Delaware County Engineer

BERLIN MEADOWS

SITE REVIEW COMMENTS

Subdivision Review Checklist and Comments Page

Figure 1

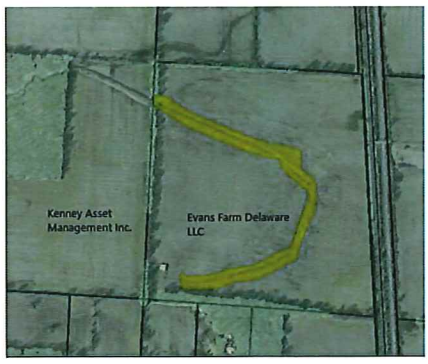
8. According to recent aerial photos, it appears that a diversion swale may have been constructed in the property to the east. This diversion may add an additional 30-acres of drainage across the development site. Please verify.

Figure 1

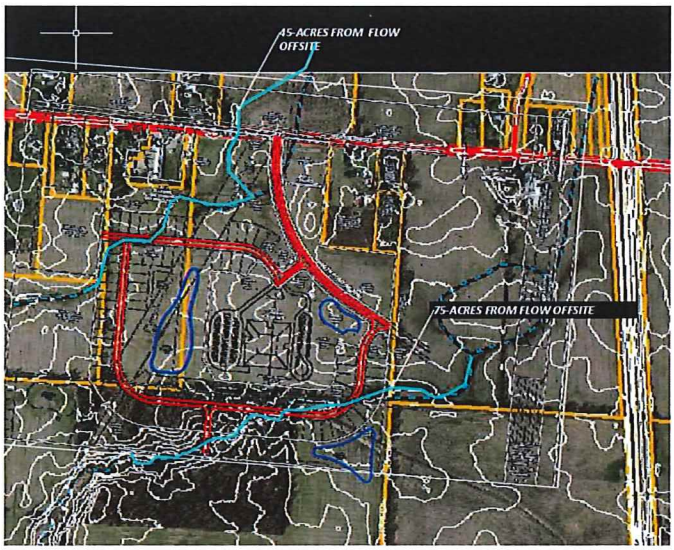
13. The retention ponds shown in exhibit appear to be located on high points on the site. Revise the layout such that detention facilities are located strategically at a point upstream and near the point where the hydraulic path crosses the property line (See Figure 2 below).

14. The west pond will require the clearing of trees (See Figure 2 below).
15. The most southern stub street terminates into the center of the stream (hydraulic path) that is tributary to significant flow from a drainage that is greater than 75-acres (See Figure 2 below). This stub street will also require a temporary turnaround due to length. Please, consider an alternate design.

16. The pork-chop-retention-pond is located on the opposite side of the outlet stream and is considered infeasible (See Figure 2 below). Please, explain design.

17. The retention located between the two proposed local streets that connect to North Road can only be used for improvements on the opposite side of North Road (pond is upstream of improvements west of North Road). Please, explain how the 100-year storm will be conveyed across North Road without overtopping that road in that event (See Figure 2 below).

18. The most southern road is located in the Griffith Ditch swale for a distance of 900-feet and will require stream relocation (See Figure 2 below). Please, provide an alternate design.
